BOTANICAL COMMENT

Portion 5 of Farm Zandhoogte 139, Mossel Bay

Figure 2: Biodiversity network (CBA) map.

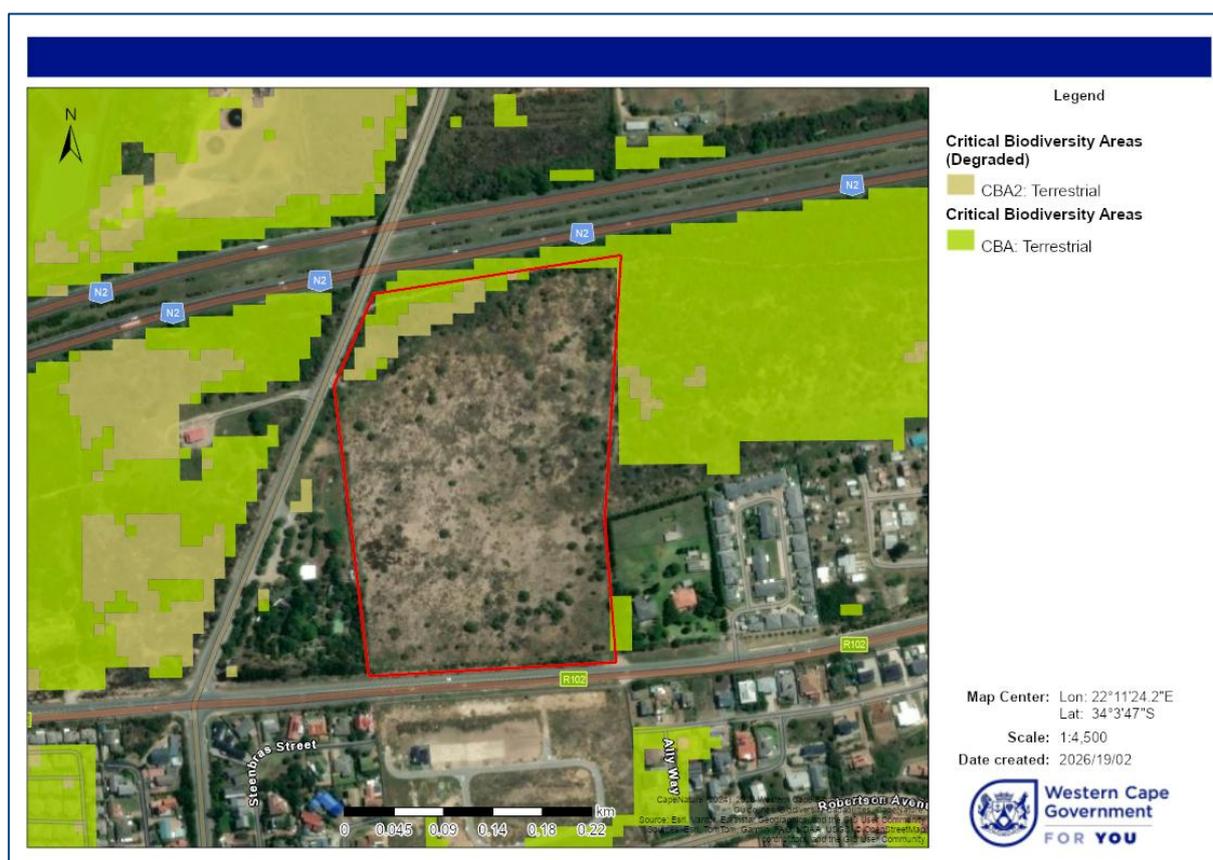
From a biodiversity network perspective, the northern side of the site encroaches on a terrestrial critical biodiversity area (CBA) and a degraded critical biodiversity area (CBA2) (see **Figure 2** above). CBA's are defined as areas in a natural condition that are required to meet biodiversity targets, for species, ecosystems or ecological processes and infrastructure². Many of these areas support known occurrences of threatened plant species, and/or may be essential elements of designated ecological corridors. Loss of designated CBA's is therefore not recommended. The site forms part of an ecological link between the Groot Brak and Klein Brak Estuaries. However, the link may have been compromised by development approvals further away to the west between the R102 and the N2! There is also an unrehabilitated or active sand mine 500 m away to the west that also impacts on the link, The areas to the north and south of the site have been transform for agricultural and residential purposes. Other (probably lesser) links run along the railway line, the N2 road reserve and primary dune above the beach.
